GMD 2 Bank Storage Feasibility

MEMORANDUM

Subject: Wichita recharge and recovery

Hydrograph of River and Groundwater Levels During pumping and nonpumping periods

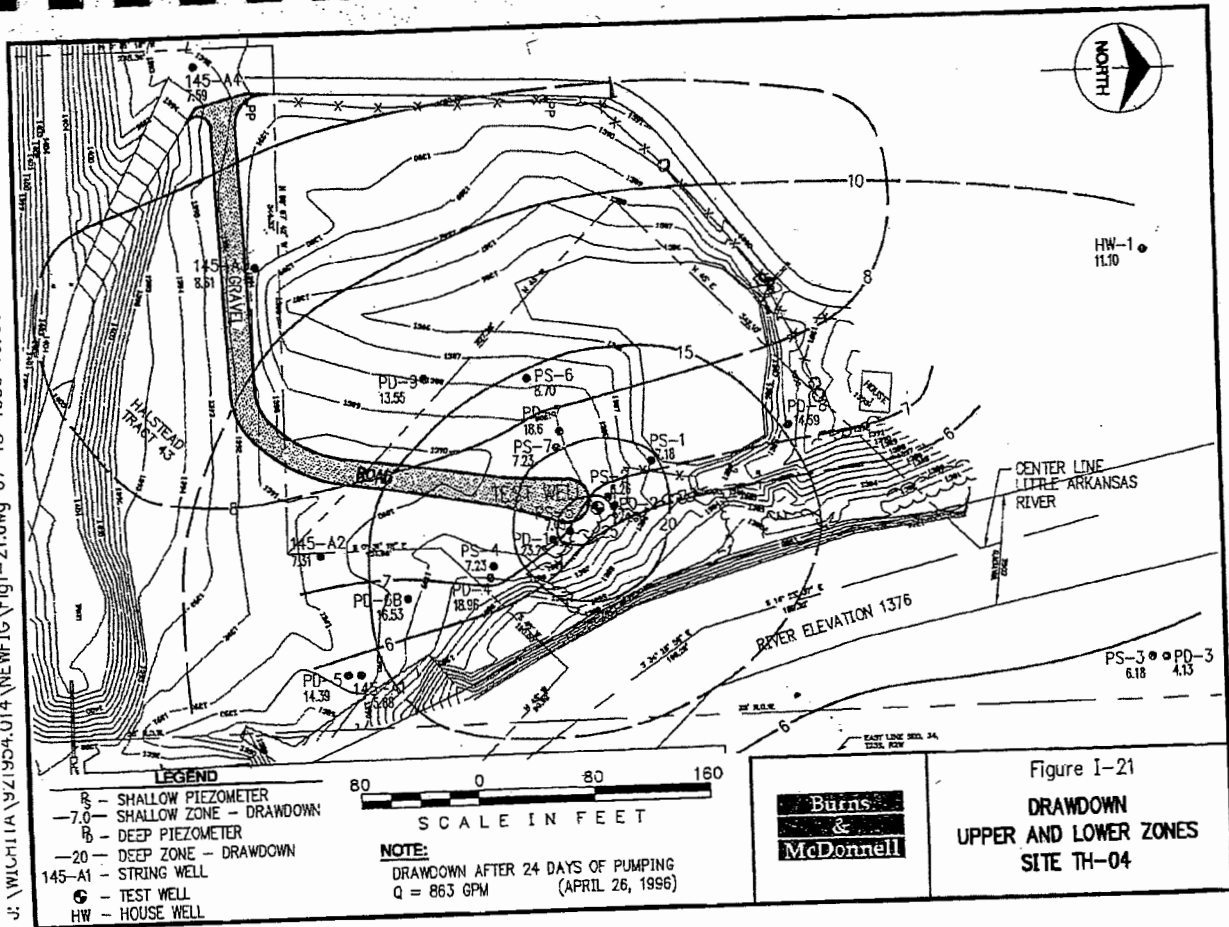
The concern of the consultant and several members of GMD #2 is that no direct communication between the Little Arkansas River and Channel to the Equus Beds aquifer exists at the test site.

The concept of pumping bank storage water only when 40 feet or more of low permeable clay exists between the water in the Little Ark channel and the aquifer is not realistic nor accepted by ~~the~~ ^{this} consultant and was of major concern by several members of the GMD No 2.

The pumping of water for the recharge project was not in compliance with the terms and conditions of term permit File No 959087 in that most of the water pumped was Equus Beds aquifer water recharged from natural precipitation and not limited to "Bank Storage Water" only.

Figure 1-20
AS-CONSTRUCTED TEST WELL AT SITE TH-04.

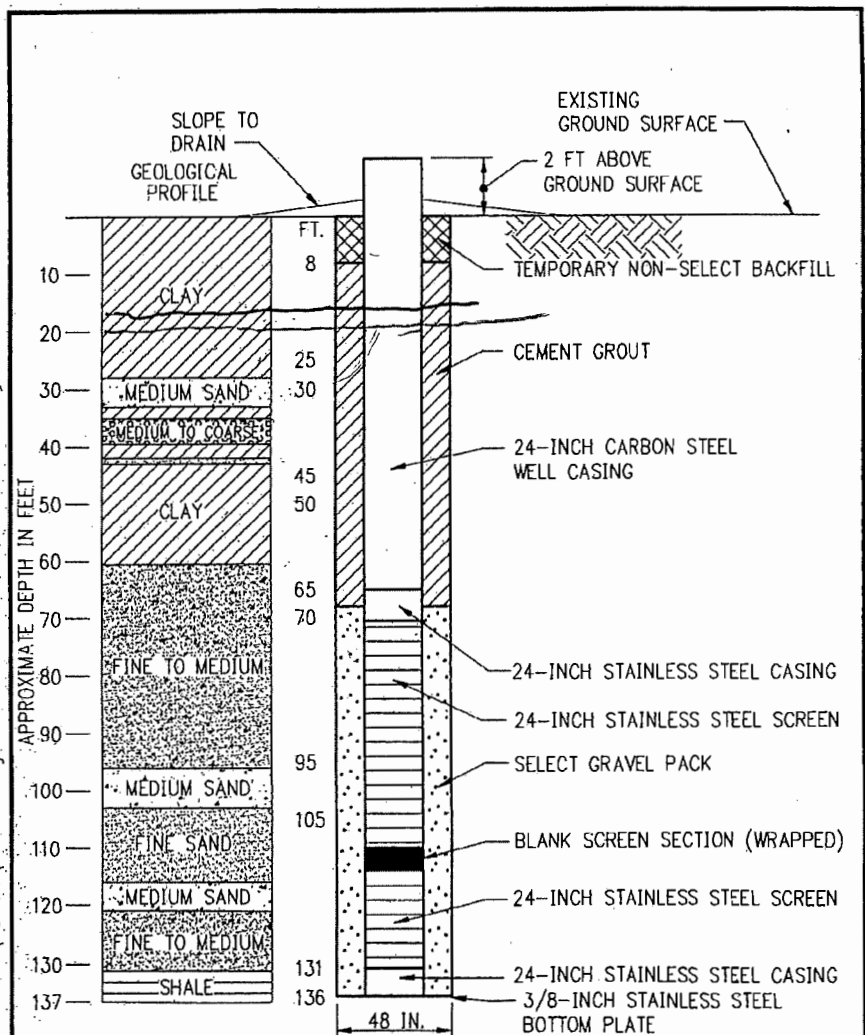
Initial concerns were expressed about the depth of the bank storage wells under the term permit for the pilot project. The wells are drilled to the base of the Equus-beds aquifer and screened substantially below the streambed. It is his argument that well logs indicate low permeability clay layers of substantial thickness exist between the top of the screen and the stream, effectively eliminating the hydraulic connection between the wells and the water temporarily stored in the banks. He further argues that the present design merely withdraws water from one location of the Equus Beds aquifer and injects it at another location capturing no stream runoff water. Well log data submitted shows clay layers of about 30 feet with a thin sand layer of less than 10 feet above the clay. About 10 feet of clay also is shown between the stream bed and the sand layer.

His conclusion is that there is no practical opportunity to pump bank storage water from the clay adjacent to the stream.
